# **VEHICLE RECALL**

G-05524 February 2006

SUBJECT: SAFETY RECALL (U.S., EXPORT)

Bus control arm bracket on certain CE and BE Bus models built between 02/10/2004 and 12/15/2005.

Figure 2. Old Bracket and Assembly

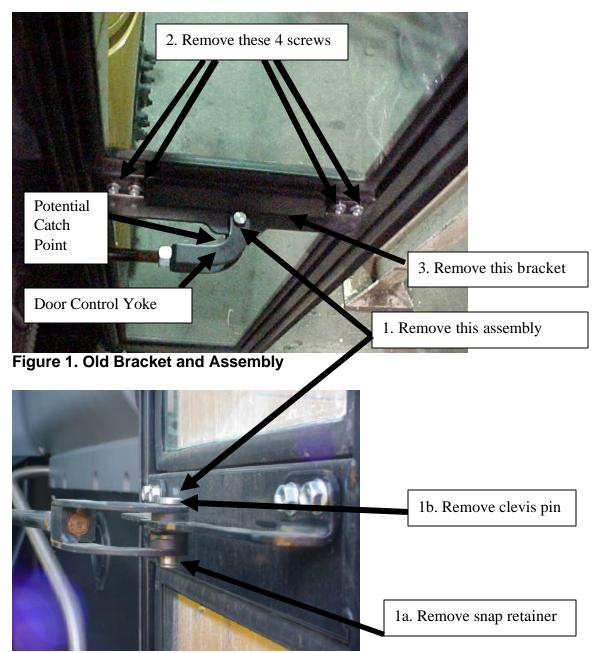
The door control bracket for the manual door control arm does not meet the guidelines in the NHTSA handbook for door entrance and handrail design. Failure to meet the guidelines can result in certain small objects, including, but not limited to, coat tie strings with draw string clips or other objects attached thereto, getting caught as the passenger exits the bus, which could result in death or personal injury.

# Remove Old Bracket: Refer to Figures 1 & 2.

- 1. Remove the door control yoke from the old bracket.
  - a. Remove the snap retainer at the bottom of the assembly.
  - b. Pull the clevis pin.
  - c. Be sure to note the order in which the parts are removed so they can be replaced or reinstalled in reverse order.
- 2. Remove the 4 screws that hold the bracket to the door. These screws are screwed into tapped holes. Be careful not to damage the threads of the tapped hole.
- 3. Once the 4 screws are removed, the old bracket can be removed.

Figure 3. New Bracket

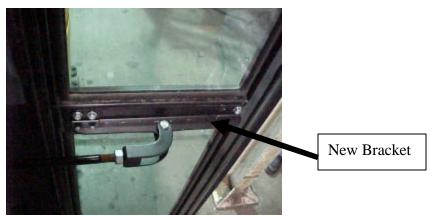
**Install New Bracket:** Refer to new bracket in Figure 3.

- 1. Place the new bracket in the same position against the door.
- 2. Replace the screws into the tapped holes on the door.
- 3. Torque screws to 15-20 LbF-Ft (20.4-27.1 Nm). Be very careful not to strip the threads in the door!
- 4. Re-attach the door control yoke to the new bracket by reinserting the clevis pin and snap ring. Ensure that spacers are positioned correctly.
